Access Compliance Report

Public Rights-of-Way

Intersection ID: 52449	Main Street: TRANQUIL_OAK_PL	Cross Street: PAT_GARRETT_ST	Location: NW
ADA ID: 17C5AC952EFB	Ramp Type: Directional1	Initial Pass/Fail: Pass	Overall Compliance: No
		Severity Score: 10

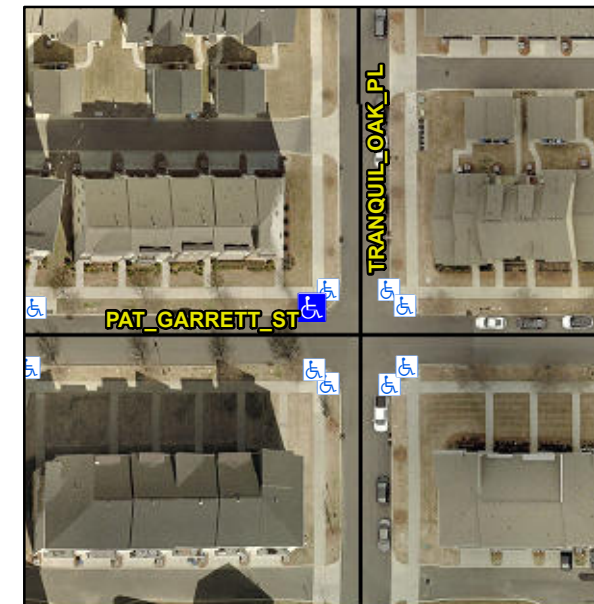
R304.5.2, R305.1.4, R305.2, R302.7.2

**Remove & Replace Entire Ramp.
Grind Gutter Lip.**
